Access Compliance Report

Public Rights-of-Way

| Intersection ID: 48791 | Main Street: HARDWOOD_WATCH_CT | Cross Street: WOODLAND_WATCH_CT | Location: S |
| ADA ID: F04EEA1E3363 | Ramp Type: Perp | Initial Pass/Fail: Fail | Overall Compliance: No |

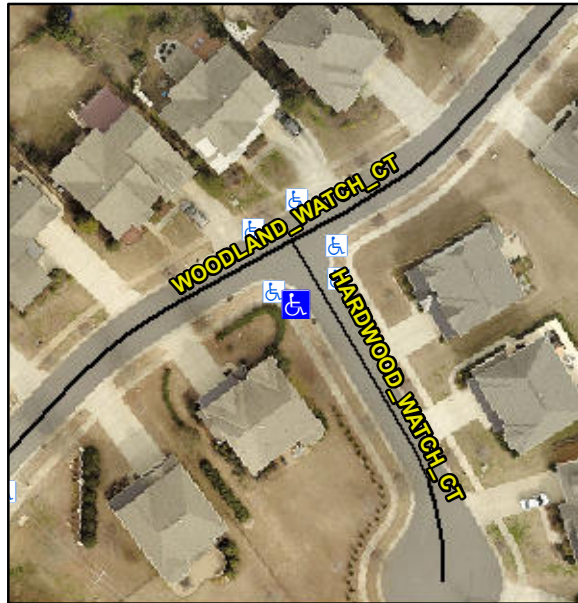
Not Found, R304.5.3

| Compliance | Description | Data | Compliance | Description | Data |
|------------|-----------------------|-------|------------|-----------------------------|------|
| Yes | Ramp Width (in) | 48.0 | No | Ramp XSlope (%) | 5.6 |

Remove & Replace Entire Ramp.
